# METROPOLITAN GOVERNMENT OF NASHVILLE AND DAVIDSON COUNTY

## STAFF RECOMMENDATION 1719 5<sup>th</sup> Avenue North February 19, 2014

**Application:** Partial demolition, Violation  
**District:** Salemtown Neighborhood Conservation Zoning Overlay  
**Council District:** 19  
**Map and Parcel Number:** 08108046100  
**Applicant:** Derek Hoevel, property owner  
**Project Lead:** Robin Zeigler, robin.zeigler@nashville.gov

<p><b>Description of Project:</b> The applicant seeks approval for work done without a preservation permit and for additional alterations to this contributing building.</p> <p><b>Recommendation Summary:</b> Staff recommends removal of the non-historic outbuilding, alteration of the existing window dimensions and the side door dimensions. Staff recommends approval of the partial demolition of windows and doors based on historic evidence and with the condition that staff approve the final window and door design and materials. Staff recommends disapproval of the front addition based on the fact that it does not meet sections V.B.1, II.B.1.e and 2.a and f and further recommends reconstruction of the original roof and porch roof forms.</p>	<p><b>Attachments</b> <b>A:

BEFORE ROOF ADDITION

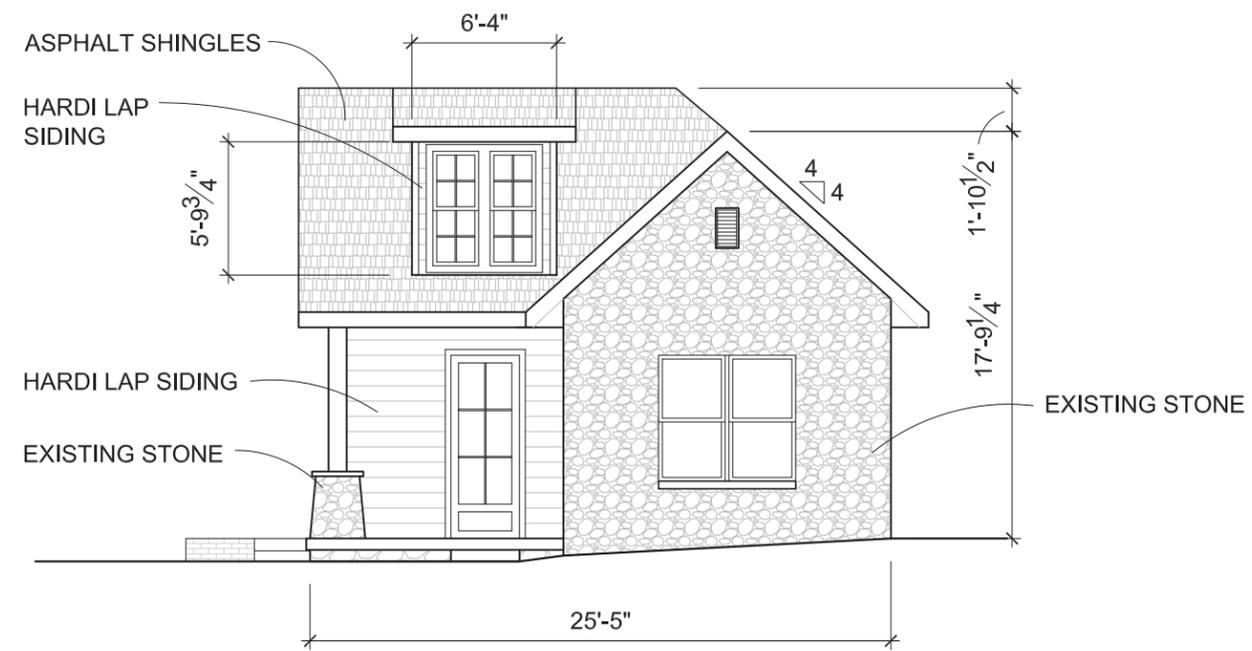
Location & Removability: The project includes a front addition that contains a front dormer and the reconfiguration of the roofline. This portion of the house is now almost two feet taller (1' 10 1/2") than it was originally. The front of the building is not an appropriate location for additions, as it changes the historic character of the building. Generally, additions should be at the rear and in some cases could be located at the side of a historic building. With the exception of replacing missing porches, front additions have not been approved on historic buildings by the Commission in the past. In addition, the front addition alters the existing roofline so it is not removable without altering the form of the house. The project does not meet section II.B.2.a and f.

Roof form: The front addition will alter the original roof form of a cross-gable with a shed roof porch to a cross-gable with a shed roof dormer and a recessed porch. Since this alteration of a character defining feature of the house dramatically changes the original roof form as seen from the street, it is inappropriate and does not meet section II.B.1.e.

**Recommendation:** Staff recommends removal of the non-historic outbuilding, alteration of the existing window dimensions and the side door dimensions, based on historic evidence and with the condition that staff approval the final window and door design and materials. Staff recommends disapproval of the alteration of the primary entrance dimensions and the front addition based on the fact that it does not meet sections V.B.1, II.B.1.e and 2.a and f and further recommends reconstruction of the original roof and porch roof forms.

# 5th Avenue Elevations

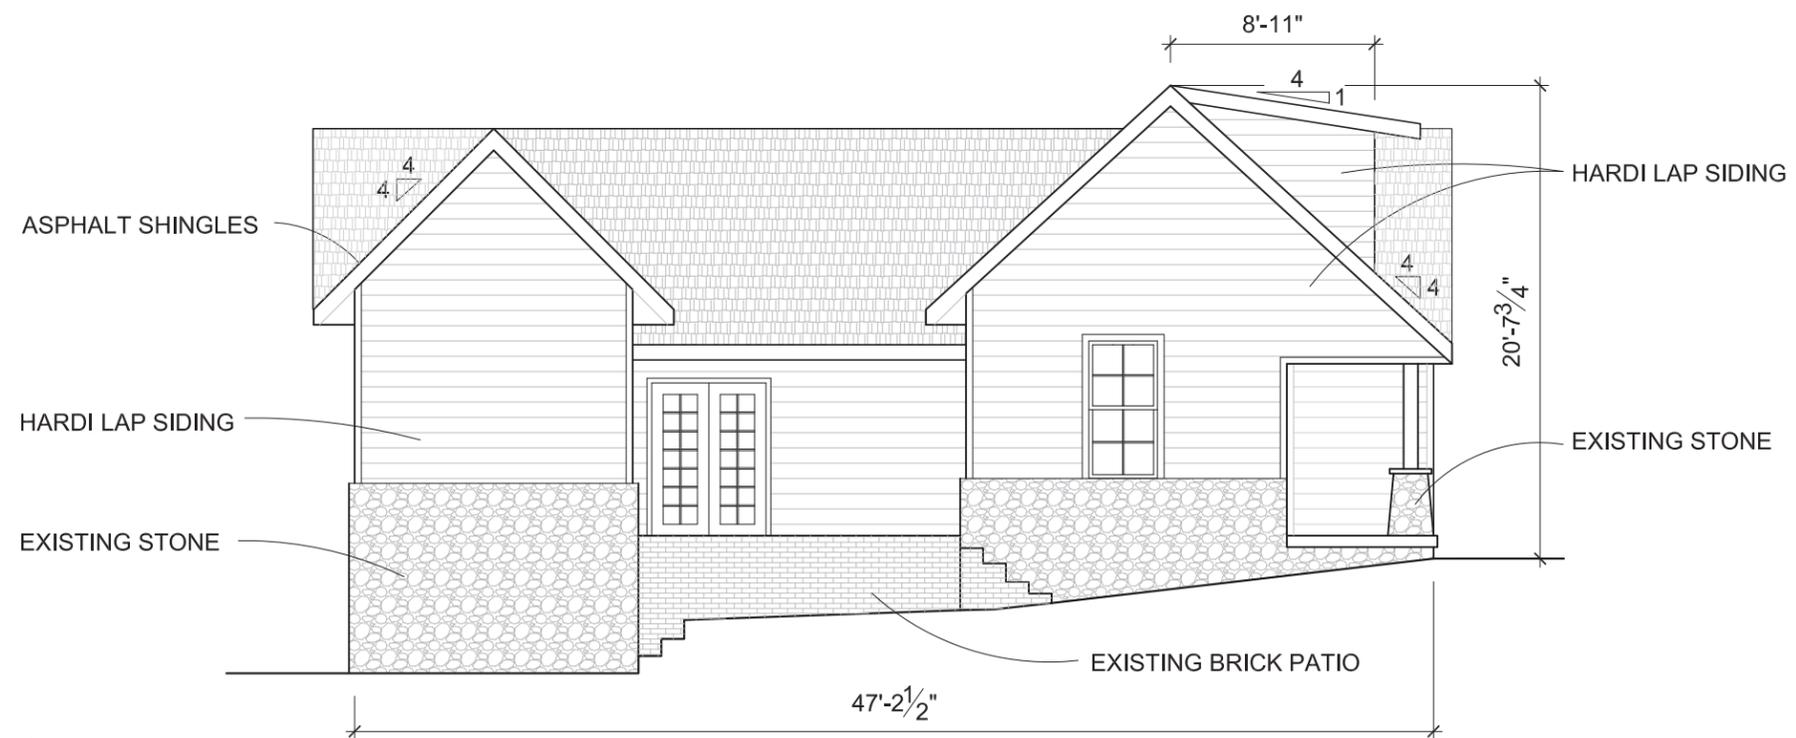
The new front door is approximately one foot taller than what it was prior to the violation. There is no evidence that it was taller historically. Full replacement, including alteration of the dimensions of the windows meets the design guidelines for appropriate partial-demolition but alteration of the primary entrance dimensions does not.

The proposed partial-demolition includes removal of the front slope of the side-gable portion of the cross-gable roof. This alteration has already taken place. Because this change alters the original roof and porch roof forms, which are character defining features of the historic house, the project does not meet the design guidelines for appropriate demolition.

and alteration of the existing window dimensions meet the design guidelines for appropriate partial demolition. Alteration of the original roof form does not meet the design guidelines for partial demolition; therefore, staff recommends that the front addition be removed and the original roof form be restored.

South Elevations

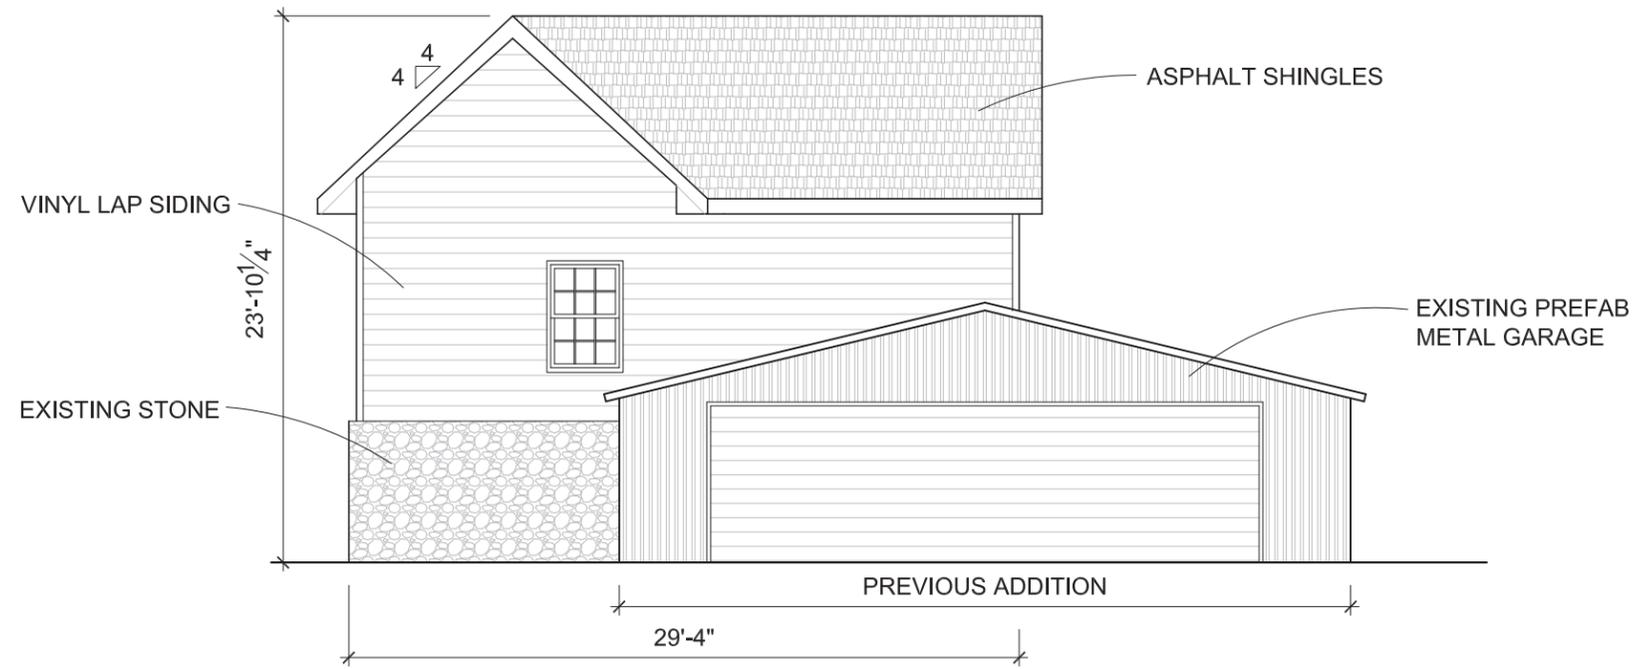
The applicant wishes to “demolish” all of the existing window and door openings. The windows will be replaced with new windows that have more historically appropriate proportions. Based on a photograph from 1964 (see image 2) the current window dimensions are not original. One window on the left side, towards the rear will be completely removed. This portion of the house is a later addition and will be minimally visible from the street. A side door will be replaced with a double door; however, this location will be minimally visible from the street and is also part of a later addition.
